**Committee of Experts on the Transport of Dangerous Goods  
and on the Globally Harmonized System of Classification  
and Labelling of Chemicals**

**Report of the Committee of Experts on the Transport of  
Dangerous Goods and on the Globally Harmonized System of  
Classification and Labelling of Chemicals on its ninth session**

**Addendum**

**Amendments to the sixth revised edition of the Recommendations on  
the Transport of Dangerous Goods, Manual of Tests and Criteria  
(ST/SG/AC.10/11/Rev.6 and Amend.1)**

**“Figure 10.1: Overall scheme of the procedure for classifying a substance or article in the class of explosives**

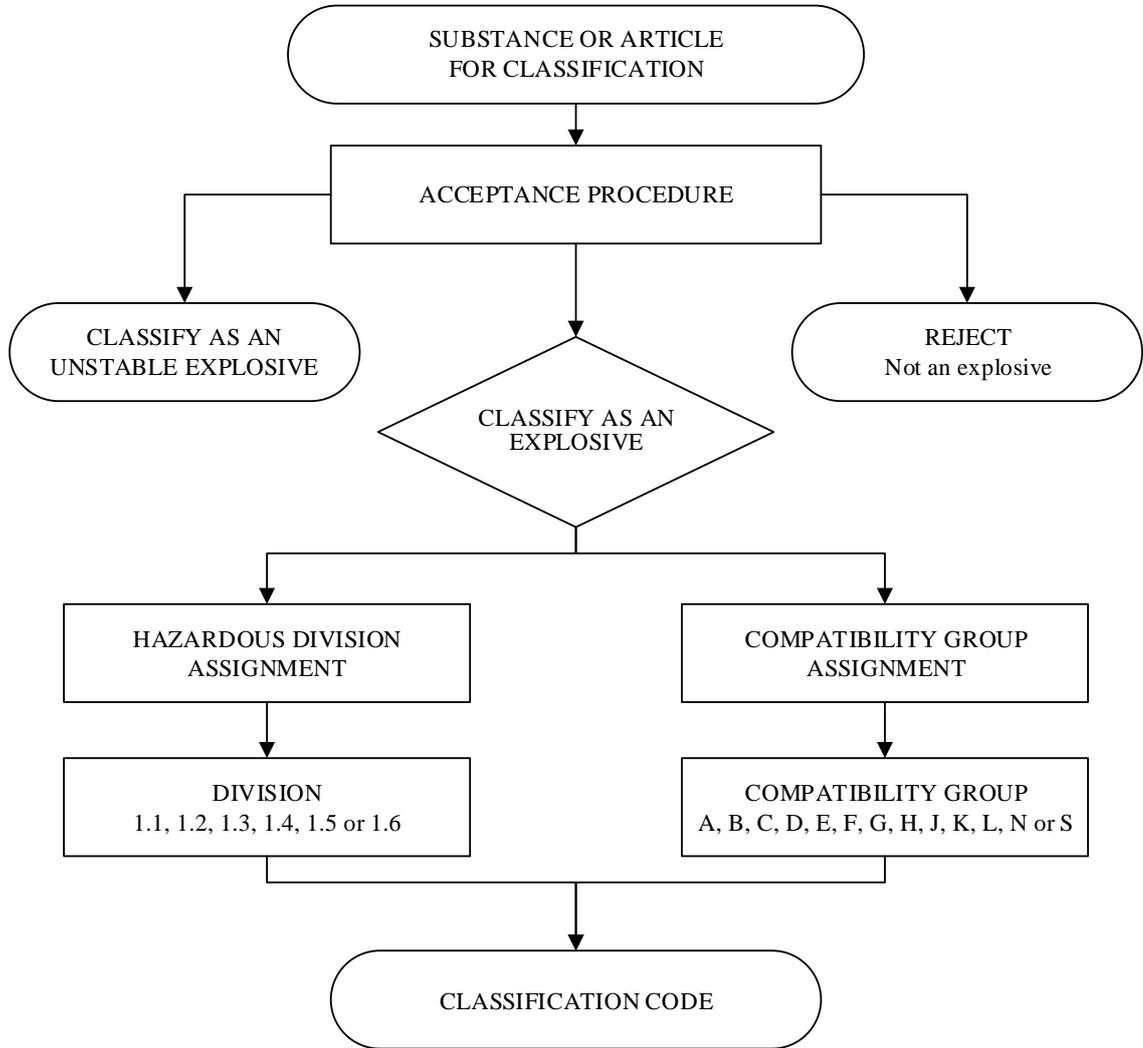
Figure 10.1 Replace the figure and its heading with the following:

**"Figure 10.2: Procedure for provisional acceptance of a substance or article in the class of explosives"**

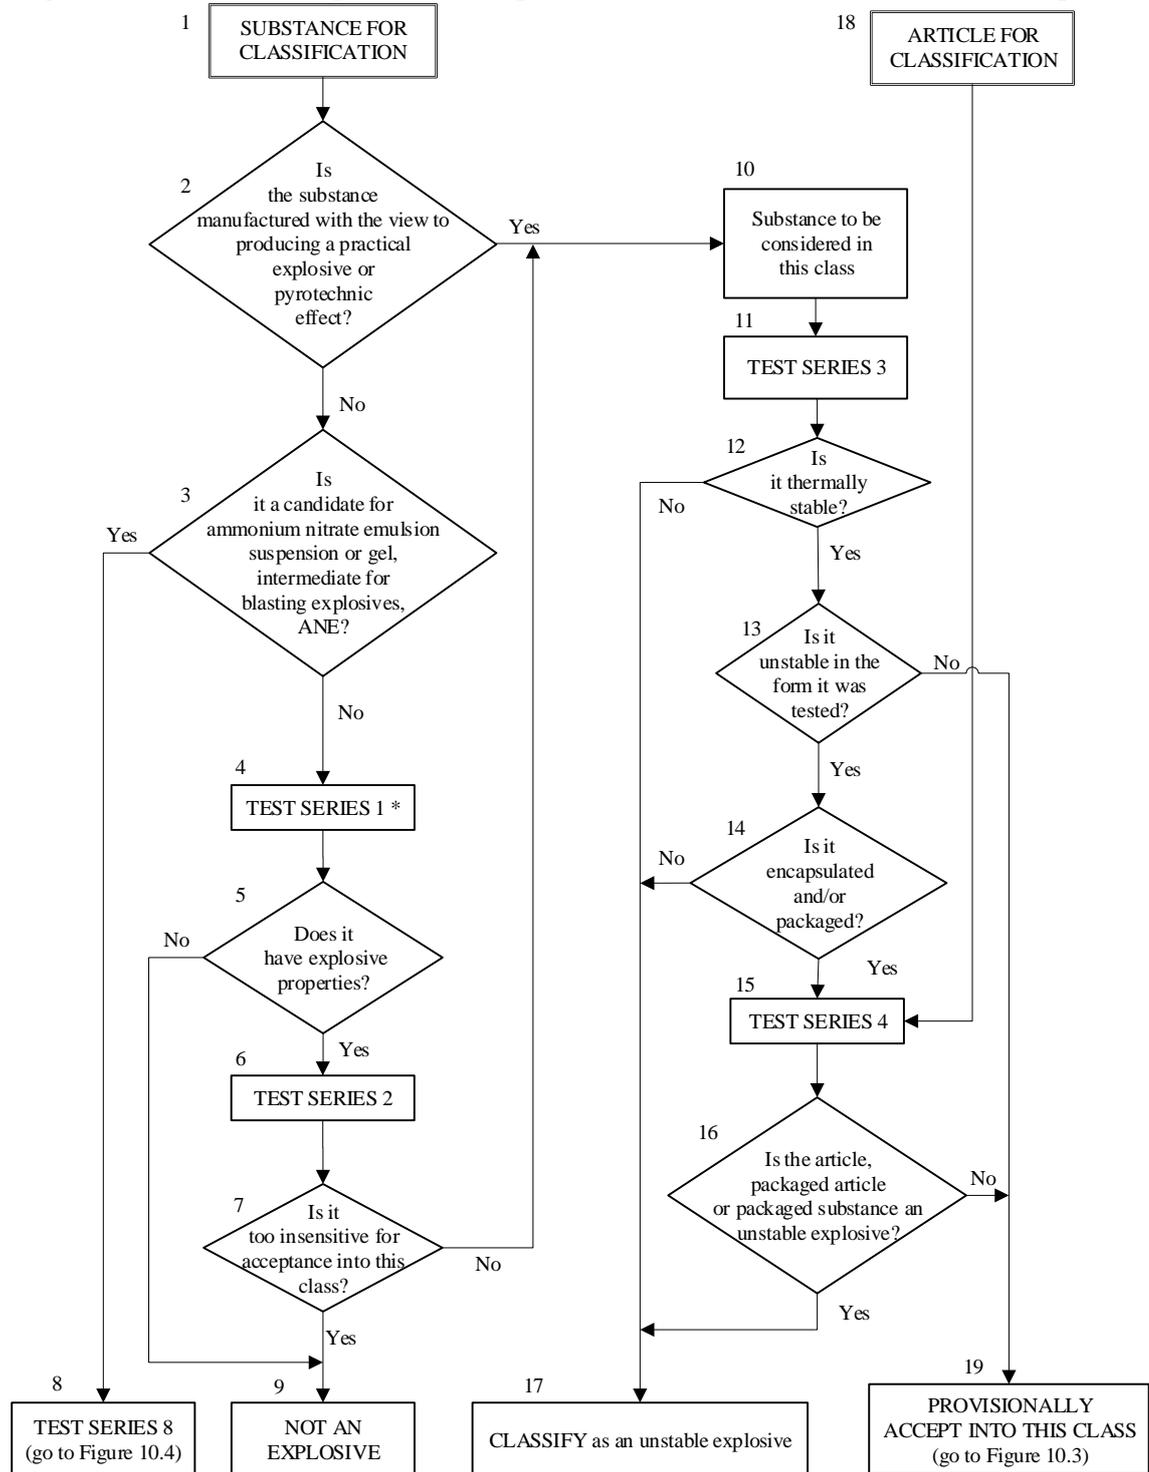
Figure 10.2 Replace current figure 10.2 and its heading with the following:

**“Figure 10.3: Procedure for assignment to a division of the class of explosives**

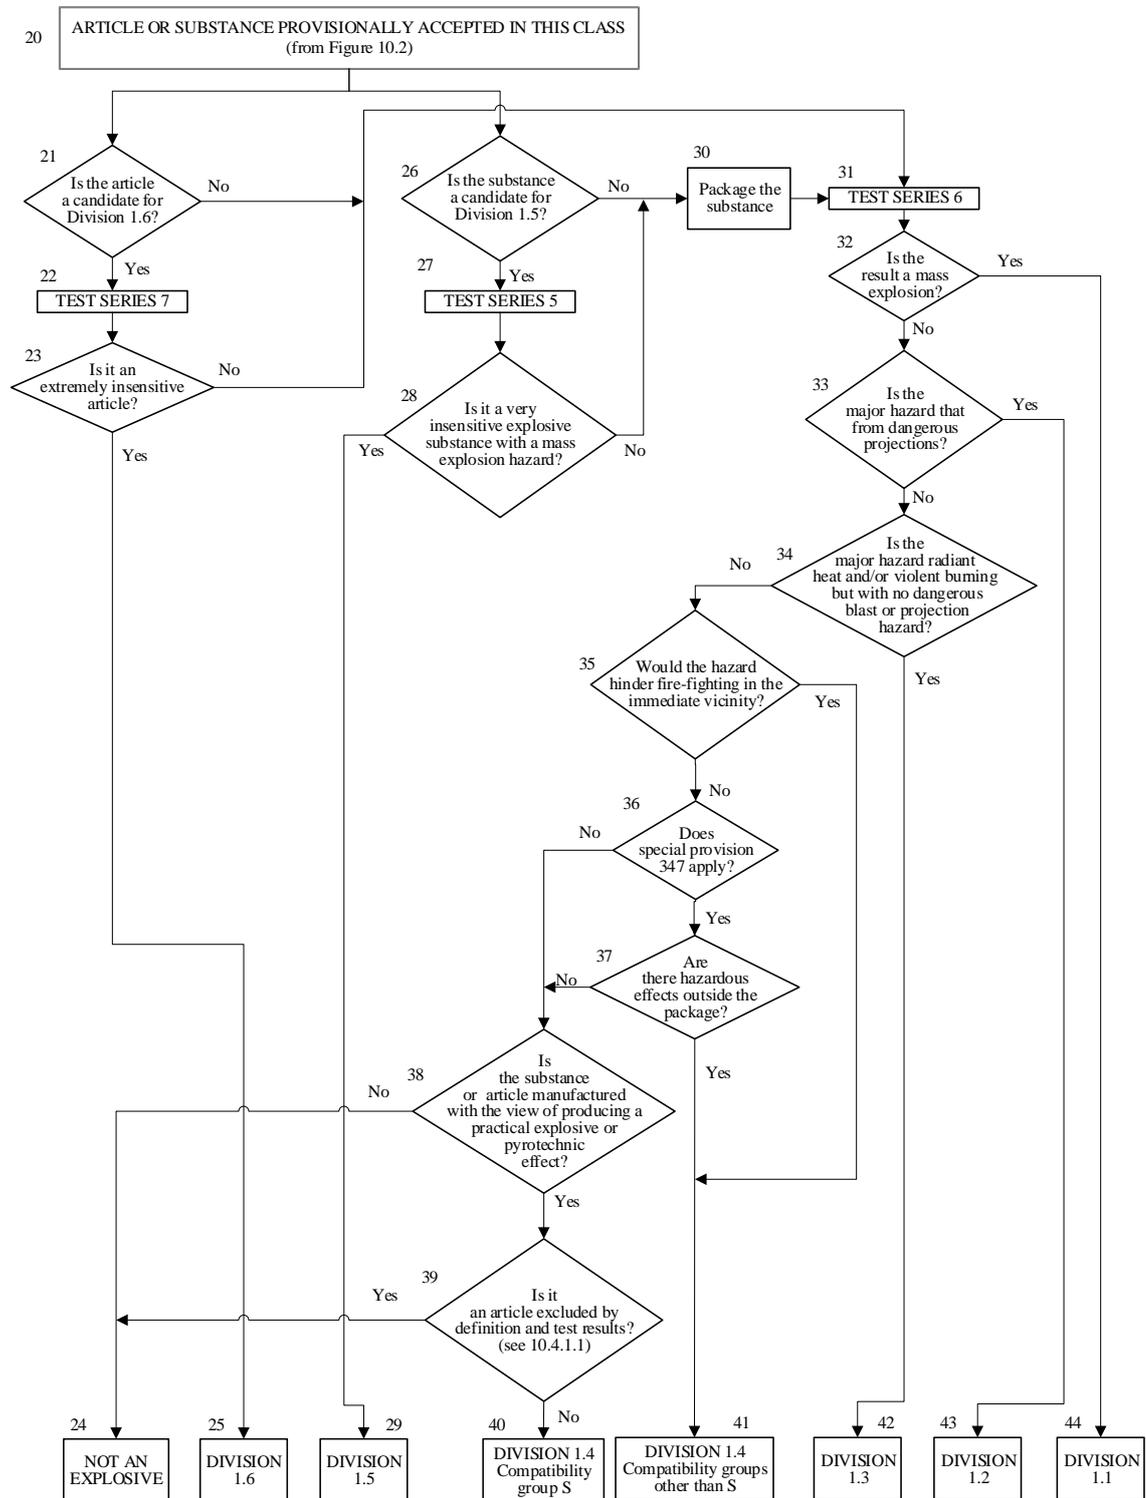
Figure 10.3 Replace the figure and its heading with the following:

**“Figure 10.4: Procedure for ammonium nitrate emulsion, suspension or gel, intermediate for blasting explosives**

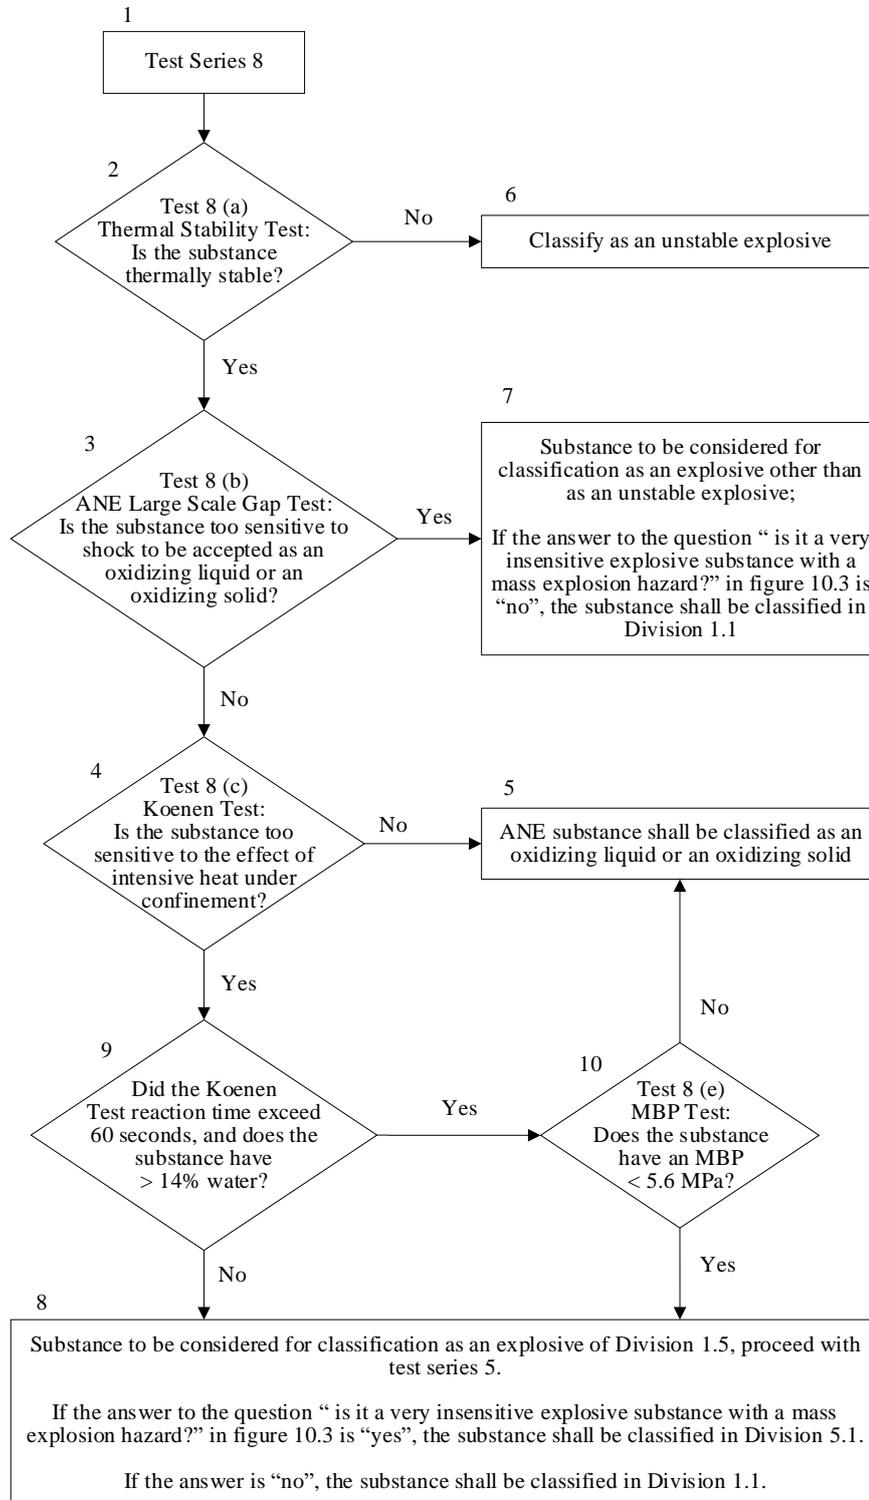
Figure 10.4 Replace current figure 10.4 with the following:

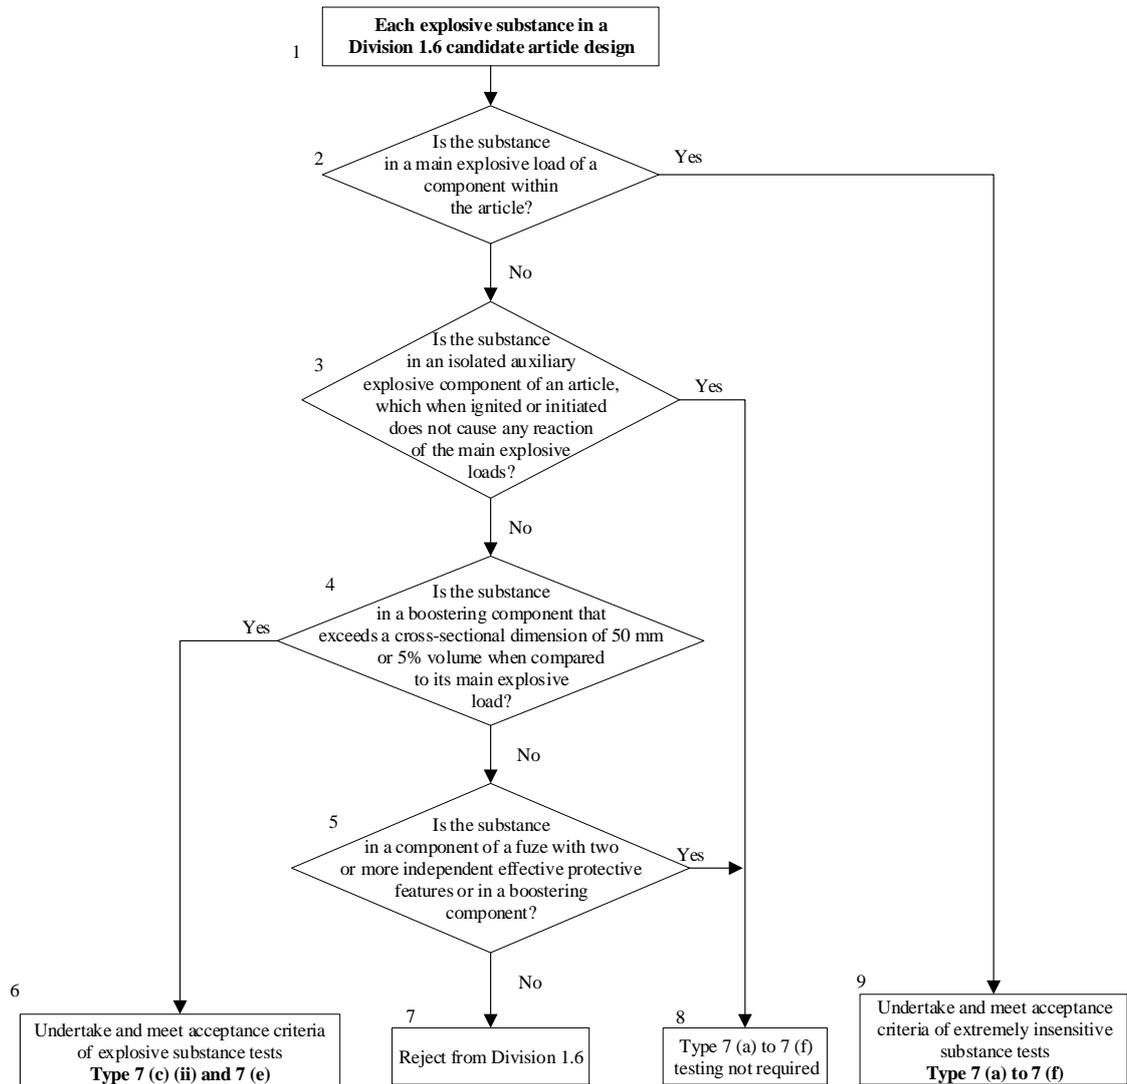
Figure 10.5 Replace the current figure with the following:

**“Figure 10.7 (b): Flow chart for the provisional acceptance of musk xylene in the class of explosives**

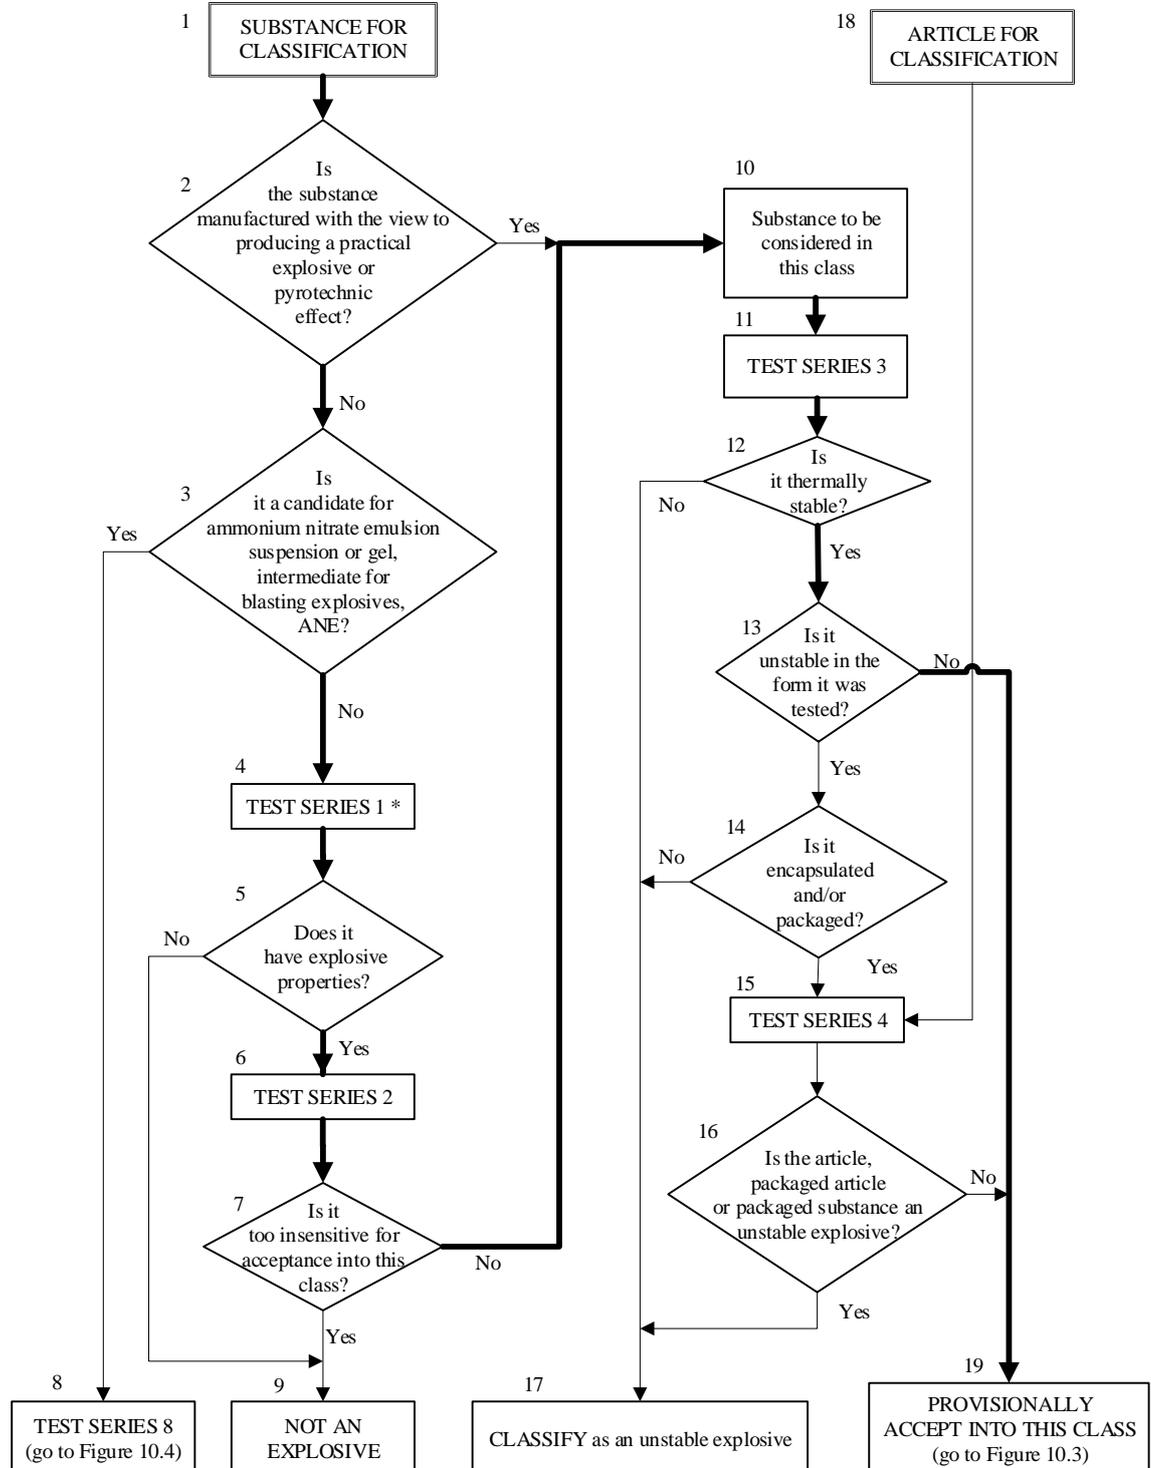
Figure 10.7 (b) Renumber current Figure 10.7 as 10.7 (b) as amended to read as follows:

**“Figure 10.7 (d): Procedure for exemption of musk xylene from the class of explosives**

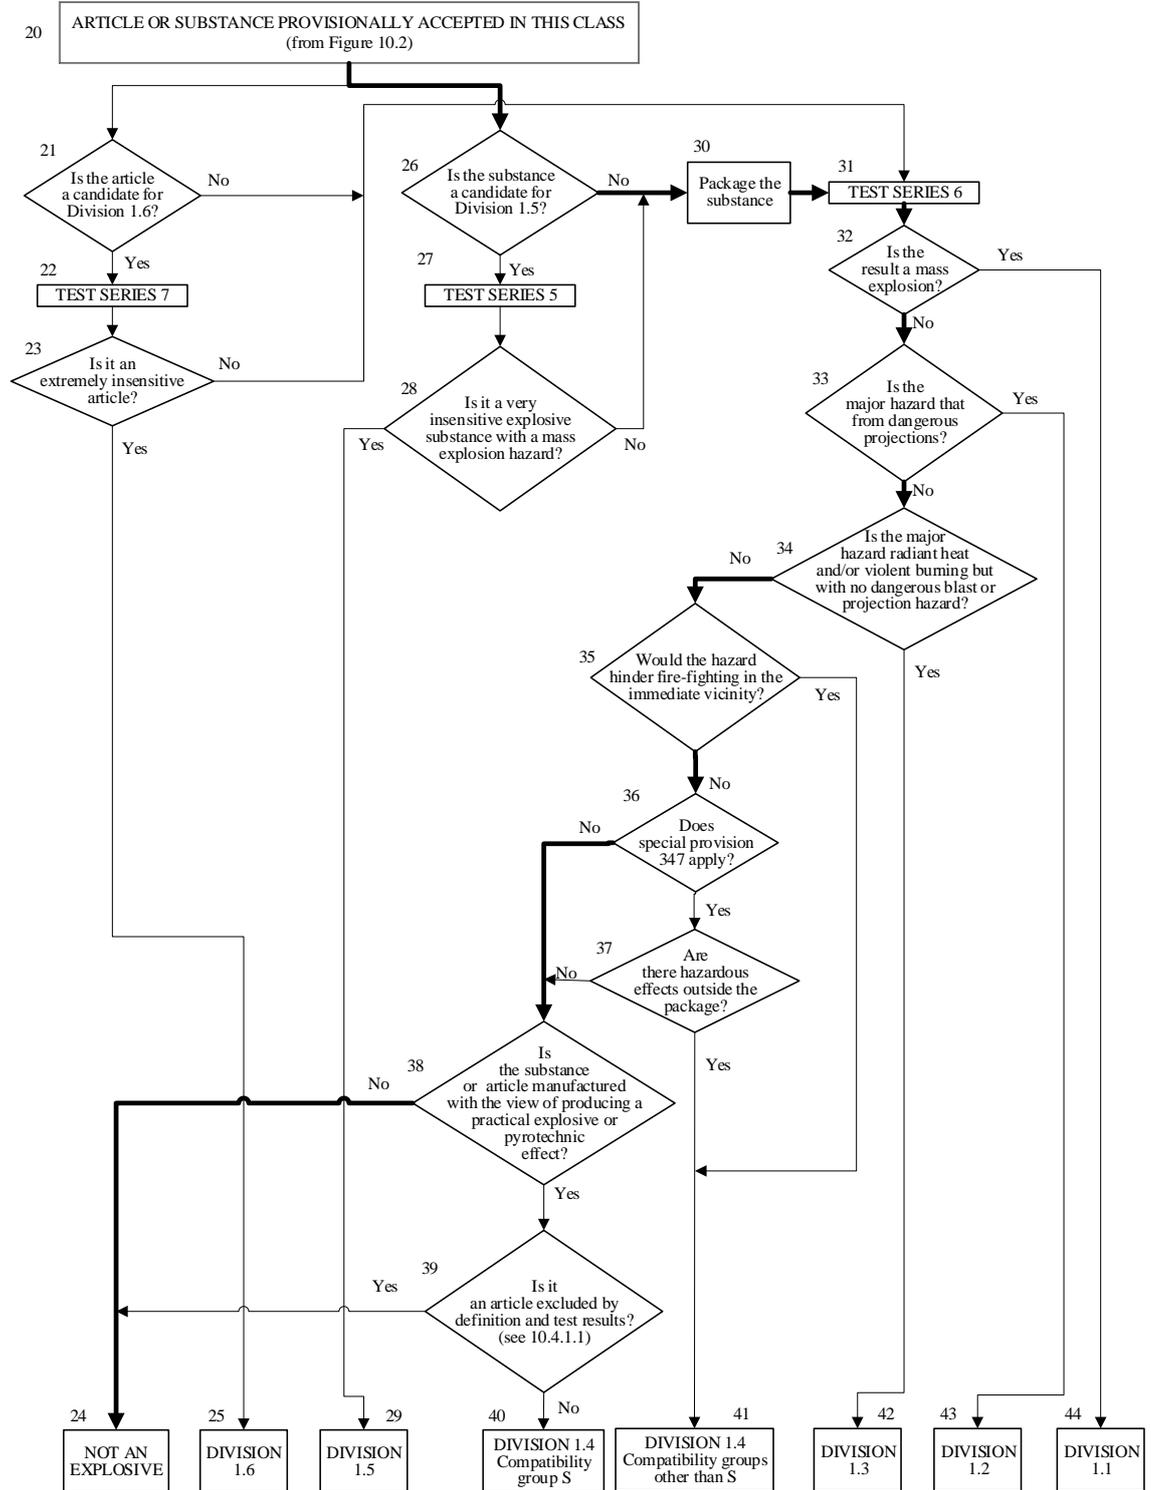
Figure 10.7 (d) Renumber current Figure 10.9 as 10.7(d), and amend to read as follows:
